Rezoning Transportation Analysis

Petition Number: 2021-160

Date	Description
08-20-2021	First Review (WB)

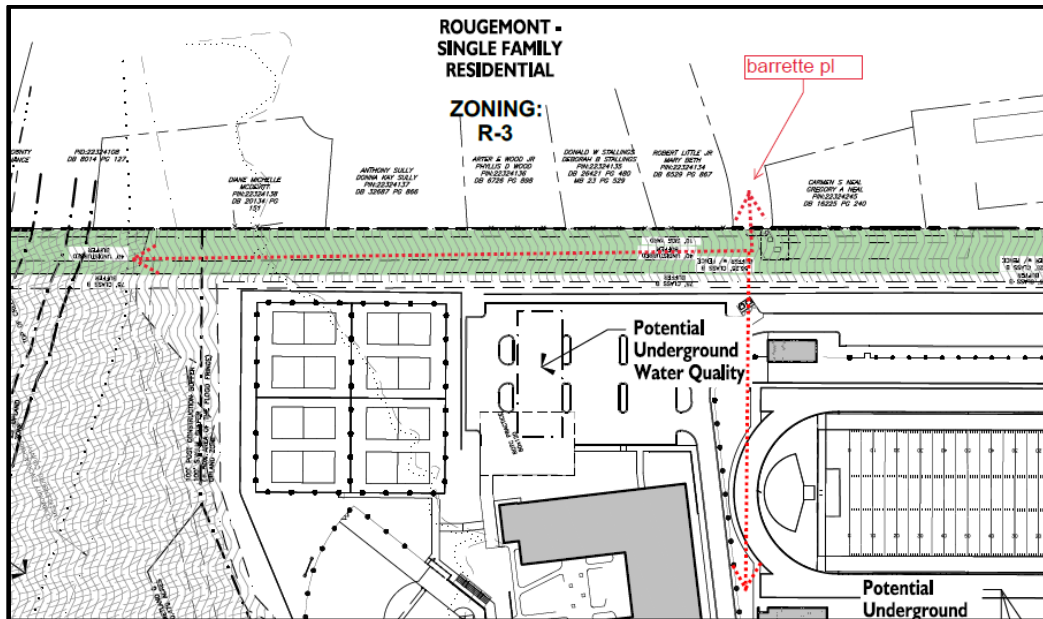
- a. **North Community House Road:** The existing curb and gutter is in its future location. No curb relocation required by CDOT.
- Johnston Road:** The existing curb and gutter is in its future location. No curb relocation required by CDOT.

Label and dimension the curb and gutter from the centerline for each road on the site plan.
